MEMO

RE: MPW Stage 3 (SSD 10431)—Response to Nell and Paul van den Bos Submission

Figure A-5 AM peak one hour traffic volumes with MPW Stage 2 construction traffic – Scenario 2 (Stage 2) in 2018

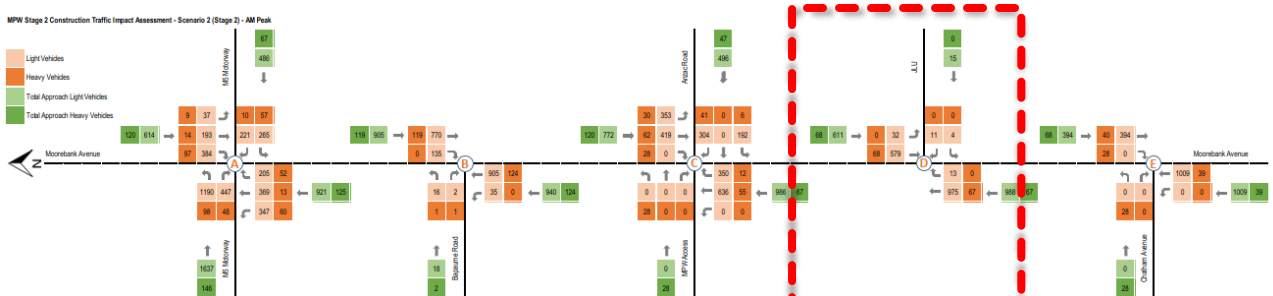
The van den Bos submission questions the change in link volumes between the intersections of Anzac Road and Chatham Avenue in Figure 5 of the submitted (April 2020).

As outlined above, that figure is provided for context only and does not replicate the MPE IMEX / JLU access from the Arcadis figures, hence there is actually an intersection between whereby some traffic may naturally ‘disappear’ from the network.

However, the submission has failed to realise that there are substantial accesses between Anzac Rd and Chatham Ave whereby this occurs. Refer below highlighted intersection from the original Arcadis figures.
